DA AMENDMENTS

Whale Beach Residence	
This Drawing must not be used for Construction unless signed as Approved	
© Copyright - This document is and shall remain the property of Walter Barda Design Pty Ltd.	
Walter Barda Design Conditions of Use: This Document may only be used for the purpose for which it was commissioned and in accordance with the terms of engagement for the commission.

Project Number	2017.15
Project Status	DA Issue
Sheet	Shadow Diagrams 12pm 21 June

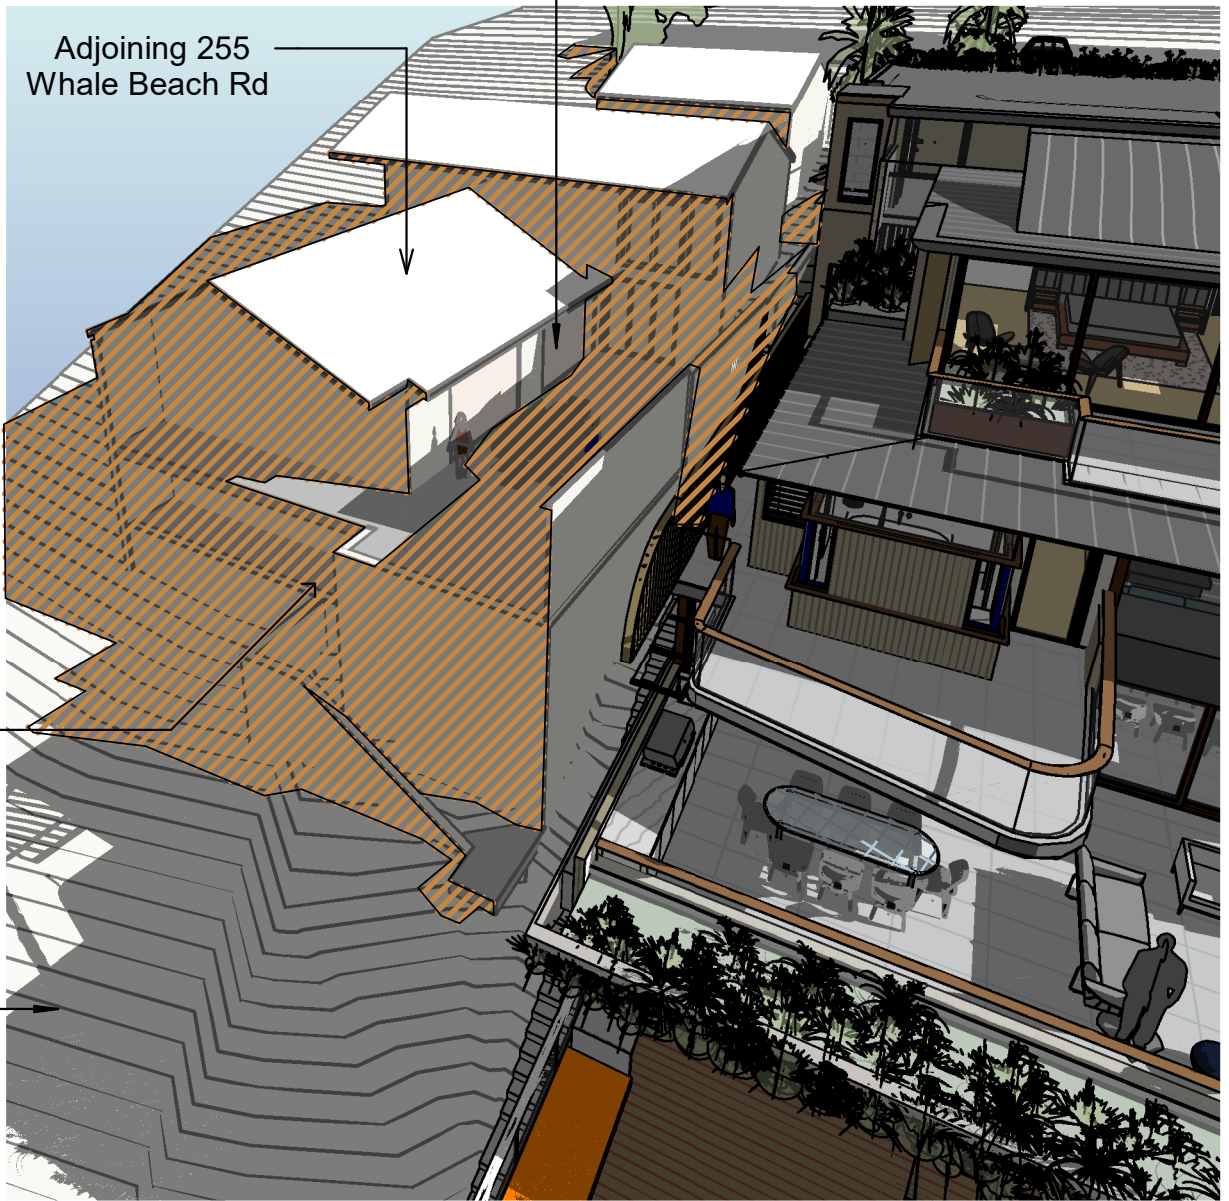
- 1A:** Stairwell Window W3.07 glazing to be obscure glass
1B: Proposed fixed splay privacy screen along terrace walkway extended by 2475mm
1C: Kids terrace balcony extent reduced by 1m at southern edge
2A: Proposed full height fixed privacy blades in front of W3.31 (south elev Master Bedroom)
2B: Reduced Master Bedroom Terrace (deletion of 1910mm x 2605mm round deck extension). Size of terrace reduced from 18m2 to 12m2. Deck increased 750mm towards east
2C: Fixed low height (525mm) planter proposed on southern end of Master Terrace balcony (2060mm x 1940mm in size) - reducing trafficable area on south end of terrace

Project Number	2017.15
Project Status	DA Issue
Sheet	Shadow Diagrams 3pm 21 June

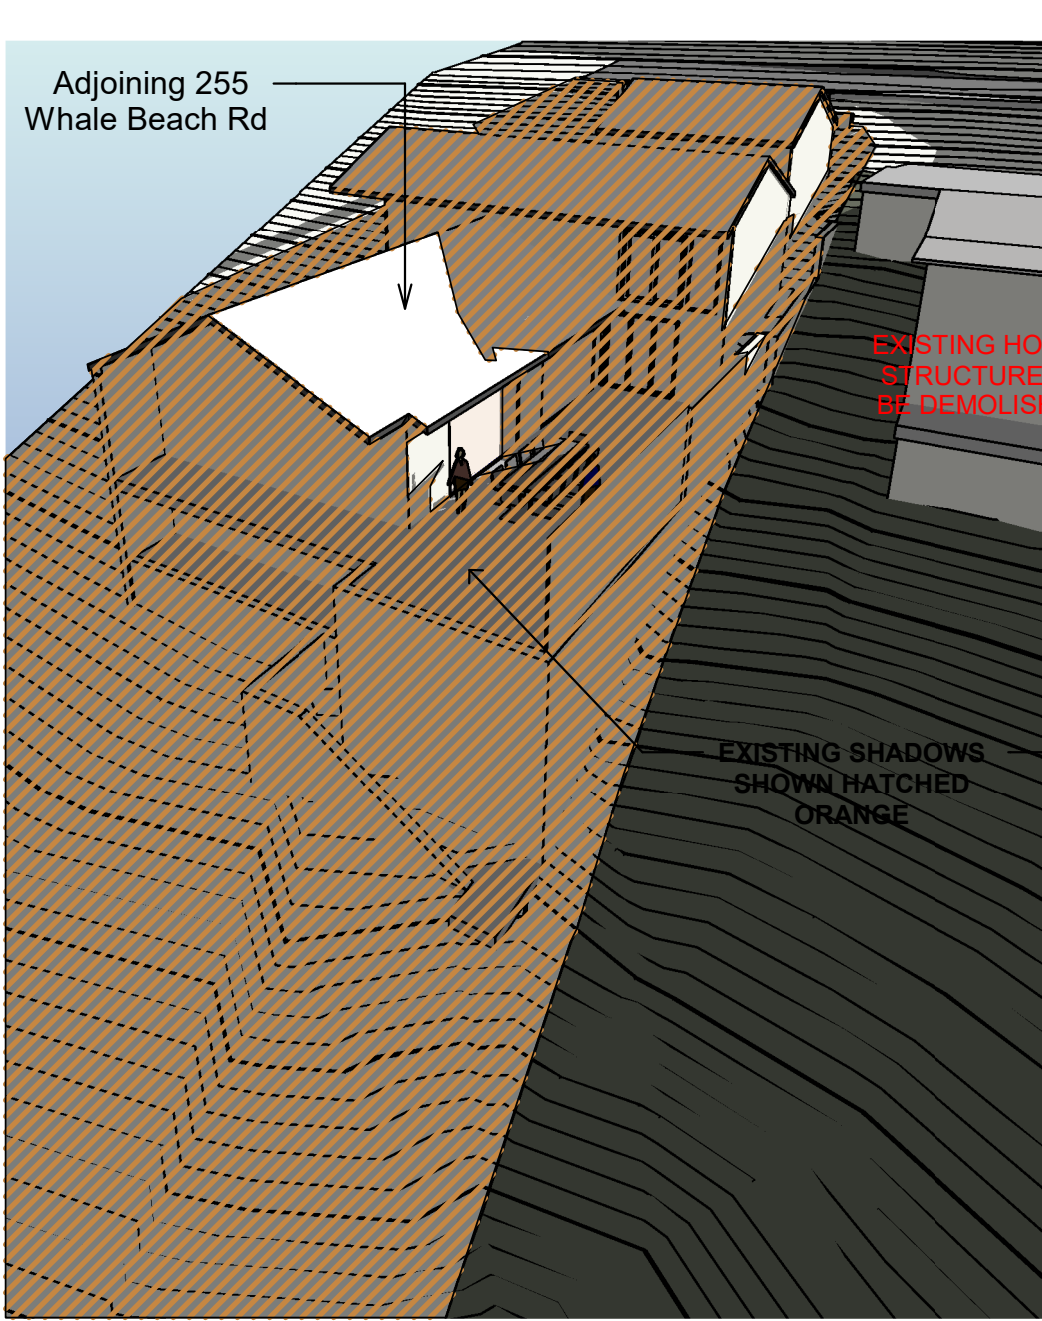
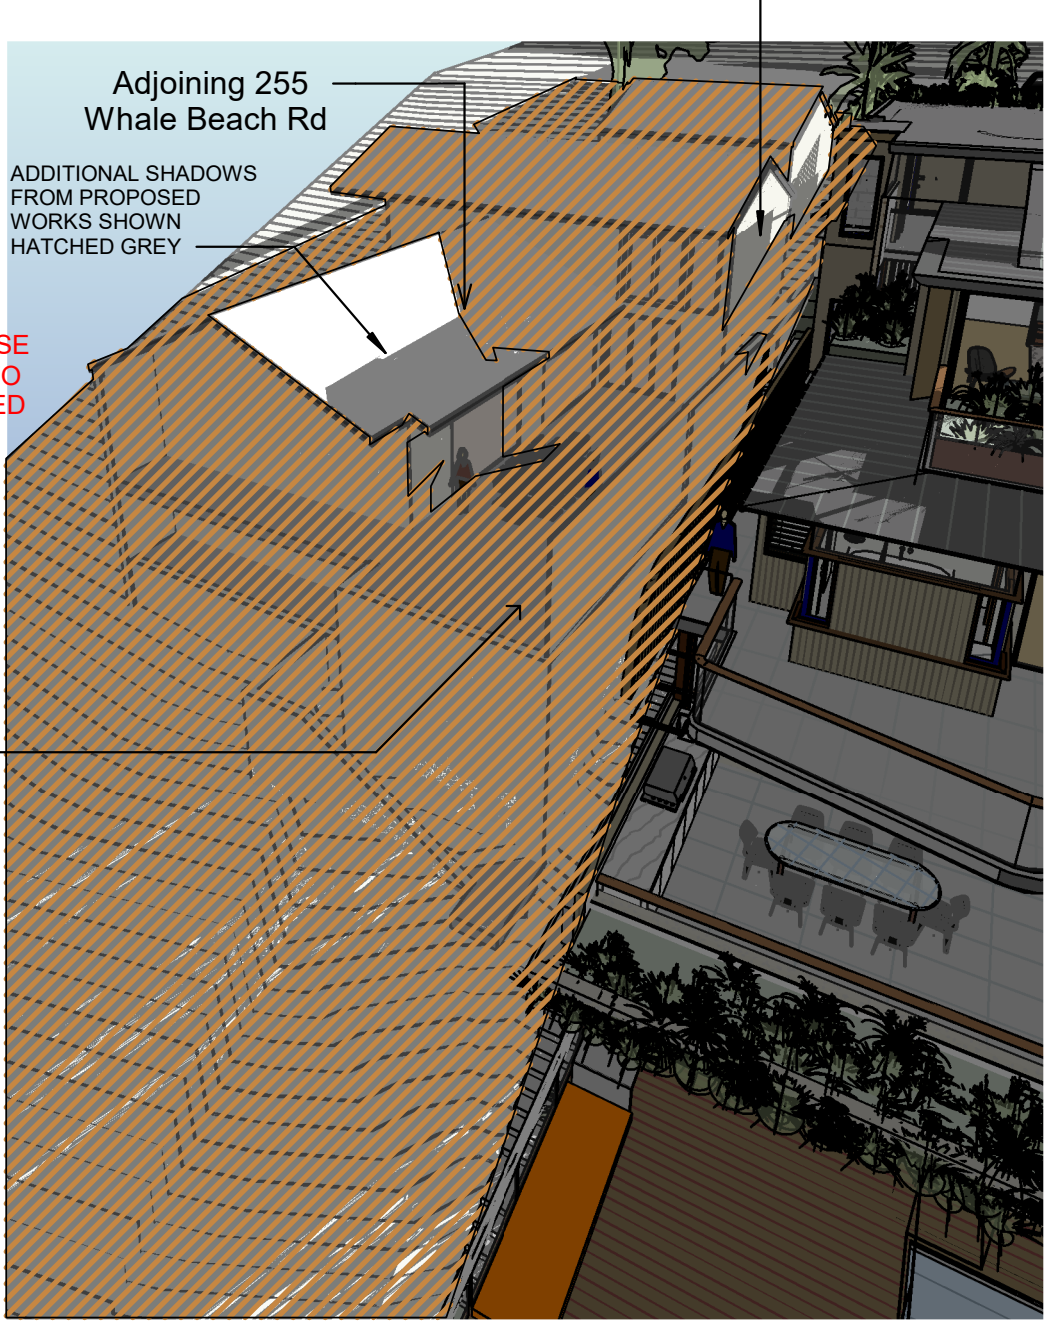
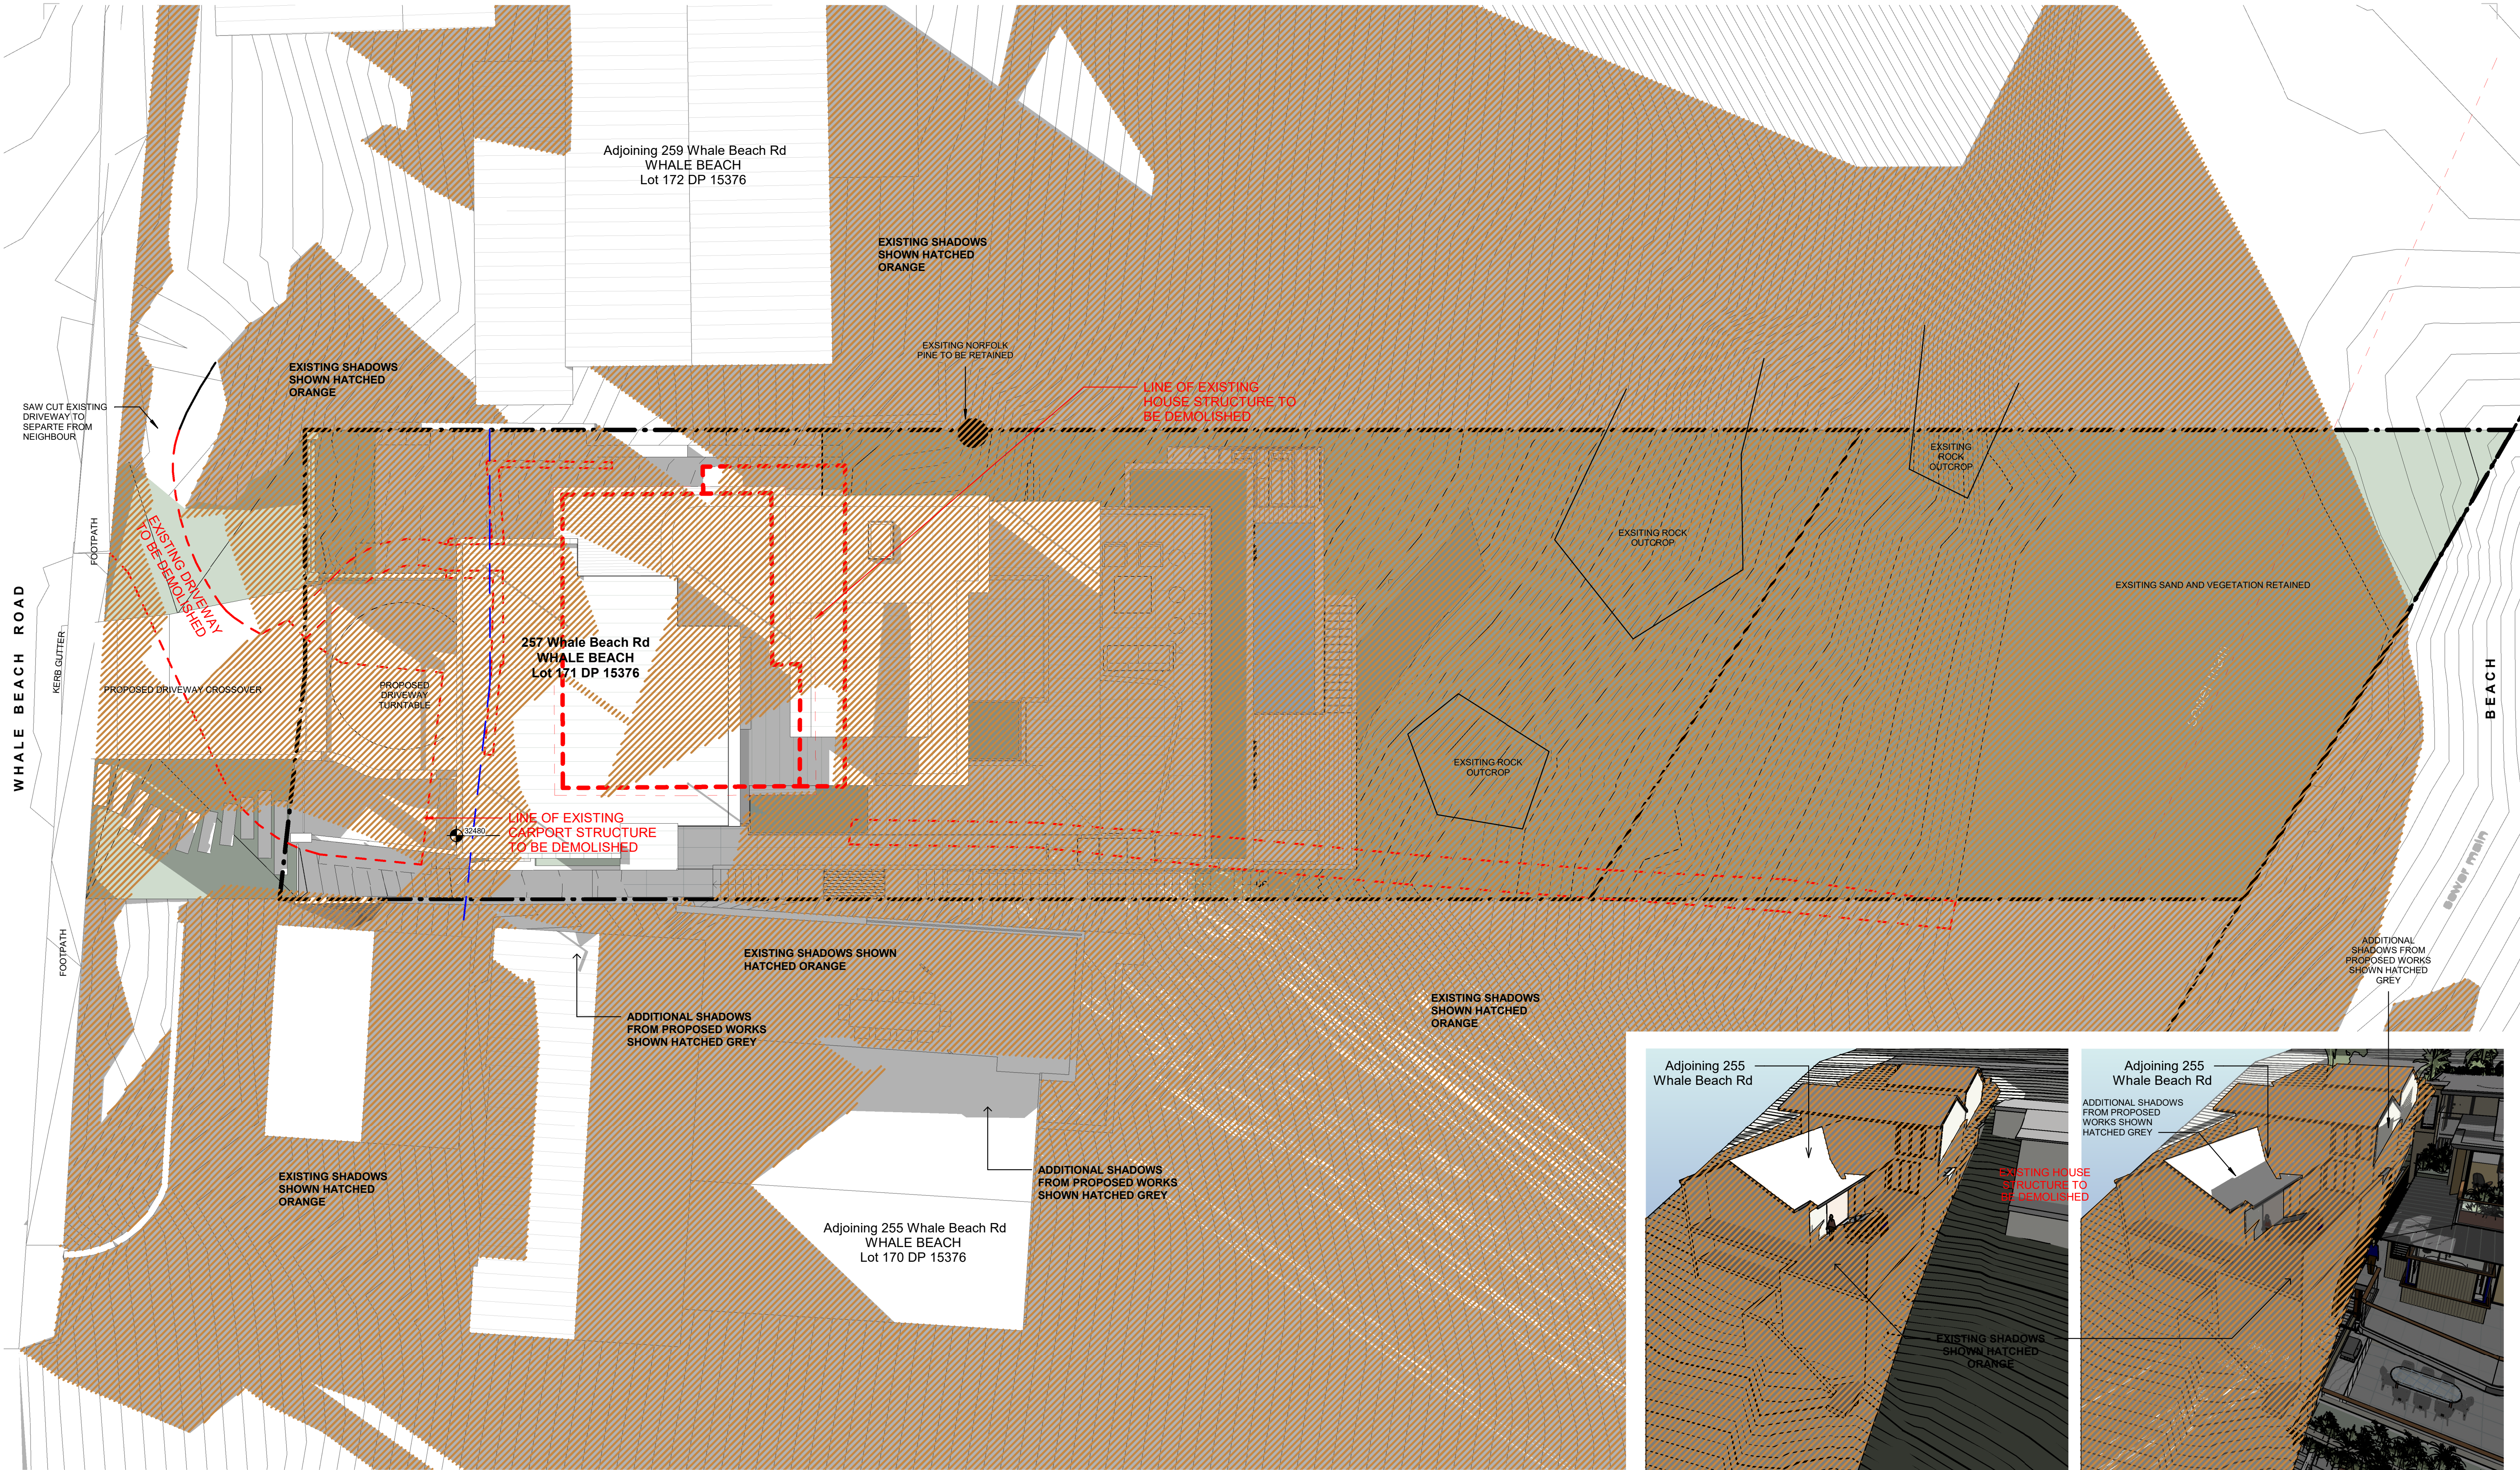
- 1A: Stairwell Window W3.07 glazing to be obscure glass
- 1B: Proposed fixed splay privacy screen along terrace walkway extended by 2475mm
- 1C: Kids terrace balcony extent reduced by 1m at southern edge
- 2A: Proposed full height fixed privacy blades in front of W3.31 (south elev Master Bedroom)
- 2B: Reduced Master Bedroom Terrace (deletion of 1910mm x 2605mm round deck extension). Size of terrace reduced from 18m2 to 12m2. Deck increased 750mm towards east
- 2C: Fixed low height (525mm) planter proposed on southern end of Master Terrace balcony (2060mm x 1940mm in size) - reducing trafficable area on south end of terrace
